# INNER WEST COUNCIL

## DEVELOPMENT ASSESSMENT REPORT

| <b>Application No.</b>                            | D/2016/348  |
| <b>Address</b>                                    | 95 Hubert Street, LILYFIELD NSW 2040  |

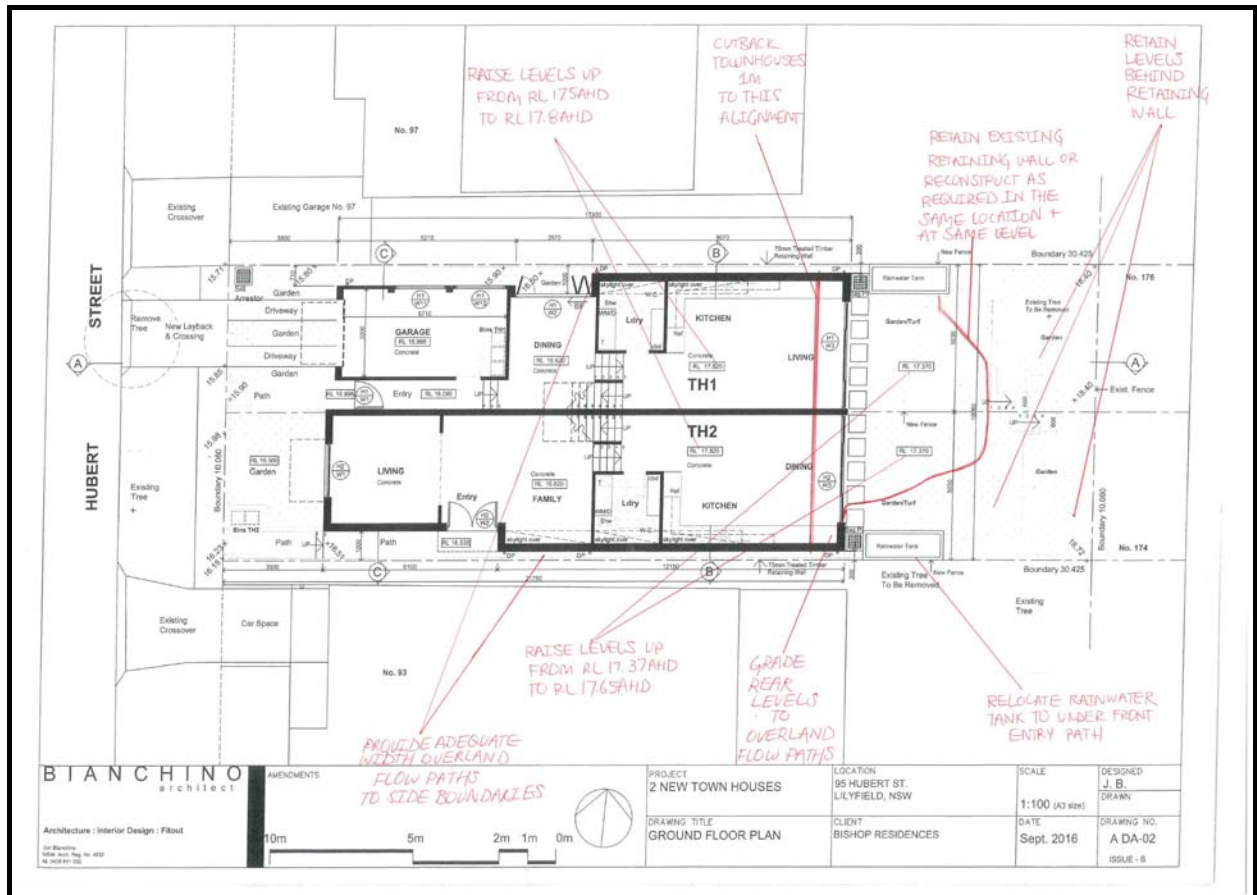
- It is considered that the proposed works (which are located within the tree's SRZ) will have a detrimental impact on its health and structural integrity therefore, the rear landscaping works, excavation and associated construction are not supported.

In light of the above, the removal of the Fiddlewood and Eucalypt in question are not supported, and in the aim of mitigating adverse impacts on the trees in question, Council's Landscape Assessment Officer (in consultation with Council's Building Surveyor and Engineers) requires the following tree protection conditions to be imposed on any consent granted:

- The proposed ground floor of Townhouse 2, which is located within the TPZ, is required to be cutback in length at the rear by 1m (so its rear alignment is similar in location to the western-most rear building footprint of the existing house) – it is noted that this will compromise amenity to the rear of this townhouse, including in terms of solar access to the rear kitchen / living space, and in order to overcome this concern, the ground and first floors of both townhouses are all to be cutback in length by 1m so that all are consistent with each other (this will also assist in reducing scale concerns raised by immediate neighbours);
